ADDENDUM NO. TWO (2)

PROJECT:
NORTHGATE TERRACE II
IMPROVEMENTS
PROJECT 2020

**BUILDING TYPE
ONE ELEVATIONS**

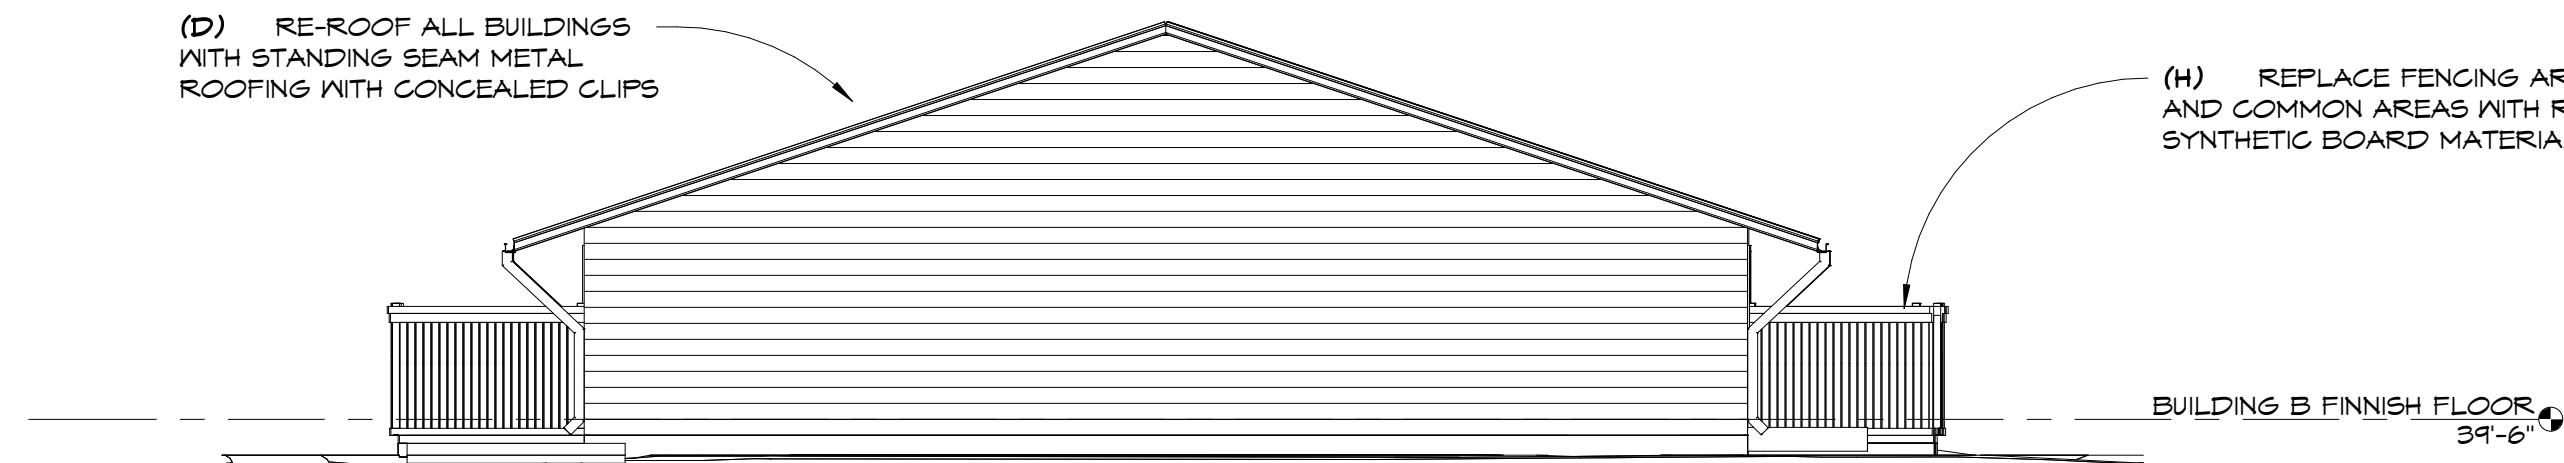
Item No. D-1: Sheet A2.00 BUILDING TYPE ONE ELEVATIONS and A2.01 BUILDING TYPE TWO ELEVATIONS:
All new Vinyl Windows to replace existing shall be included as Alternate No. 1.
Notes have been added to indicate that window and window installation shall comply with Florida Building code and design pressures indicated on Sheet A4.0 DOOR AND WINDOW DETAILS.

THE FBC PRESCRIBES PERFORMANCE AND CONSTRUCTION REQUIREMENTS FOR EXTERIOR WINDOWS AND GLASS DOORS INSTALLED IN WALL SYSTEMS. TESTING BY AN APPROVED TESTING LABORATORY IS REQUIRED, AND APPROVED LABELS MUST IDENTIFY THE MANUFACTURER, PERFORMANCE CHARACTERISTICS AND APPROVED PRODUCT CERTIFICATION AGENCY, TESTING LABORATORY, EVALUATION ENTITY OR MIAMI-DADE NOTICE OF ACCEPTANCE (NOA).

INSTALLATION:
THE PROPER ATTACHMENT OF THE WINDOW TO THE STRUCTURE IS CRITICAL TO THE PERFORMANCE OF THE WINDOW. THE MANUFACTURER SPECIFIES HOW ITS IMPACT-RESISTANT WINDOWS MUST BE INSTALLED TO OFFER THE MAXIMUM AMOUNT OF PROTECTION WHEN CONFRONTED BY STORM-DRIVEN DEBRIS. FOLLOW THE "PUBLISHED MANUFACTURER'S RECOMMENDATIONS" FOR DESIGN PRESSURES INDICATED ON SHEET A4.00.
